INTERIOR—A-PILLAR TRIM WARPED—VEHICLES BUILT FROM 8/7/1998 THROUGH 8/26/1999	Article No. 99-21-6

FORD: 1999-2000 WINDSTAR

Figure 1 - Article 99-21-6

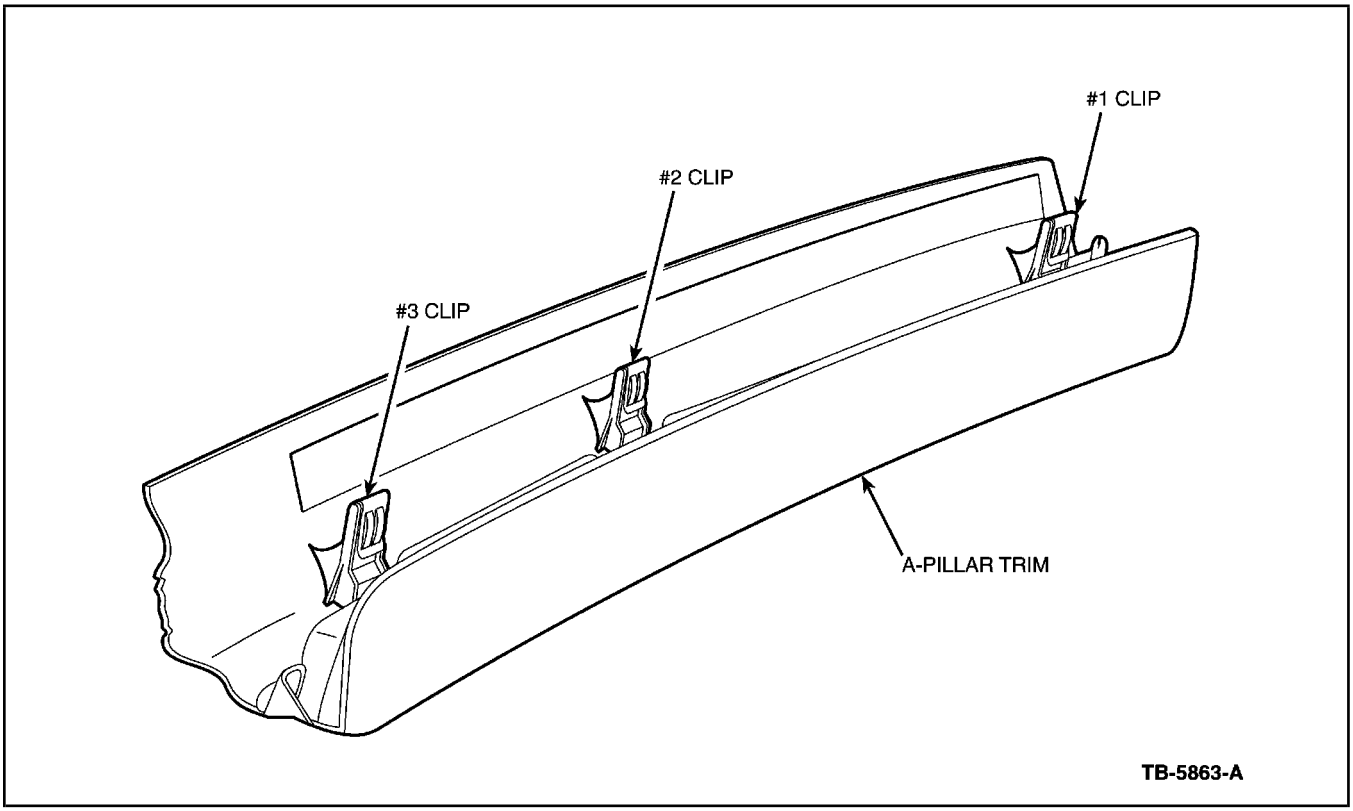
1. Remove the warped A-pillar trim from vehicle.
2. Obtain a new A-pillar trim from service stock.
3. Remove the #3 retaining clip (bottom of trim piece) by cutting off the plastic sail area (Figure 1).
4. Cut two slits approximately 10mm long into the plastic base of #2 clip (#2 clip is located middle of trim piece) at the two areas indicated (Figure 2).
5. Install the reworked trim piece onto the A-pillar.
